Our Ref: 407/FYLD/03

Your Ref: NYM/2017/0533/CVC & NYM/2017/0892/CVC

**RE: UPDATE ON DISCUSSIONS REGARDING CONDITIONS 14, 15 AND 30 OF PLANNING APPROVAL NYM/2014/0676/MEIA AT WOODSMITH MINE**

Figure 5-2 Indicative monitoring locations surrounding RAF Fylingdales

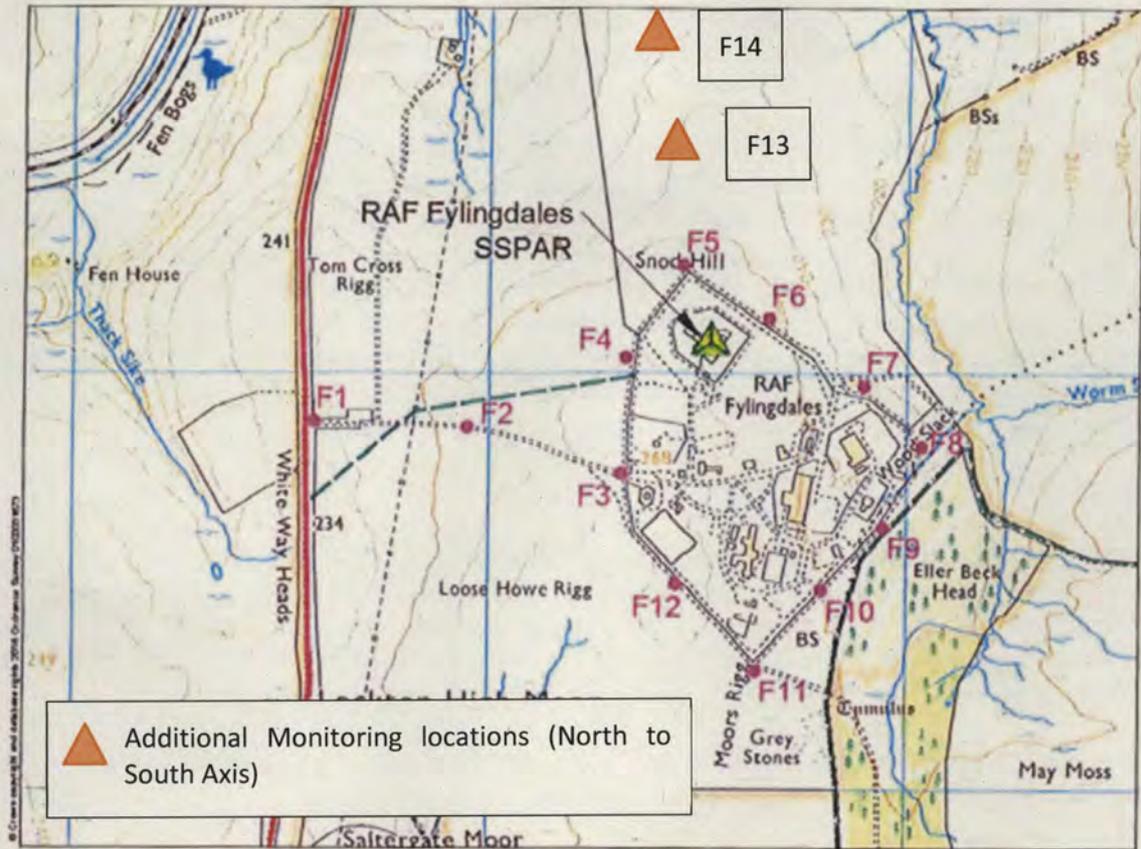
SMP has agreed to the installation of 2 additional monitoring locations to provide the basis for a north-south profile to be constructed from the future dataset. The plan below shows SMP's proposed monitoring locations and the MoD's suggested location for the 2 additional monitoring points.
